Field Safety Notice

Subject: Software error in *Resampling* Function
Product affected: OmniPro-Accept, Version 7.4a
SW function affected: *Resampling* of measured curve(s)
Type of action: Do not use the *Resampling* function
FSCA-identifier: CAPA-2013-002

The following screenshots illustrate the error's reproduction:

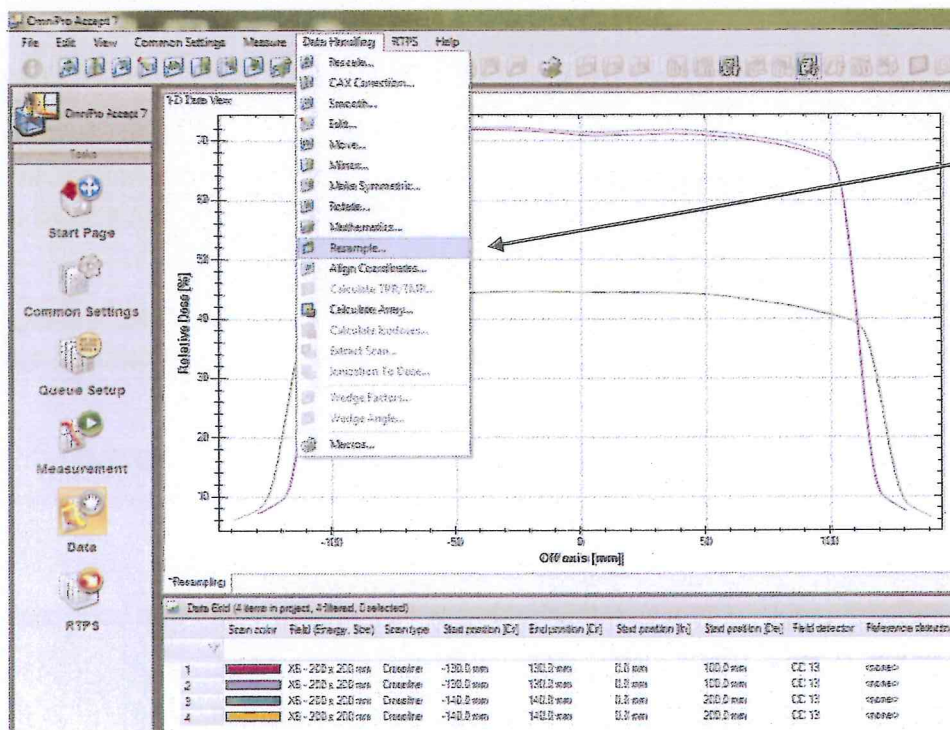
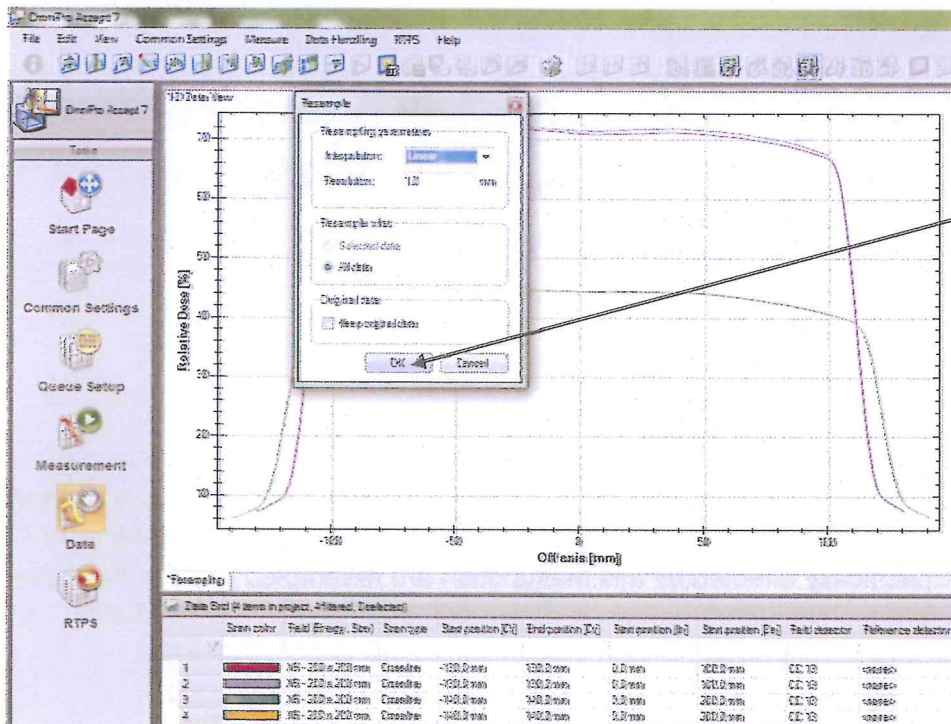
Error occurs if:

Menu item
Resample...
is selected

Problem description:

Using the *Resampling* function for profiles measured without reference chamber results in a mirrored profile curve. X and Y coordinates are flipped, Z coordinates are not affected.

- a. To prevent this specific error from occurring, and for best measurement results, always use a reference detector.
- b. Avoid the use of the *Resampling* function for profiles measured without reference detector. Perform the measurement with the requested step-width from your TPS system.

- c. The *Resampling* function can be performed a second time (as illustrated above). This reverses the X and Y coordinates again to the original correct orientation. Attention: The reversal will occur with every resampling. Careful observation is required.
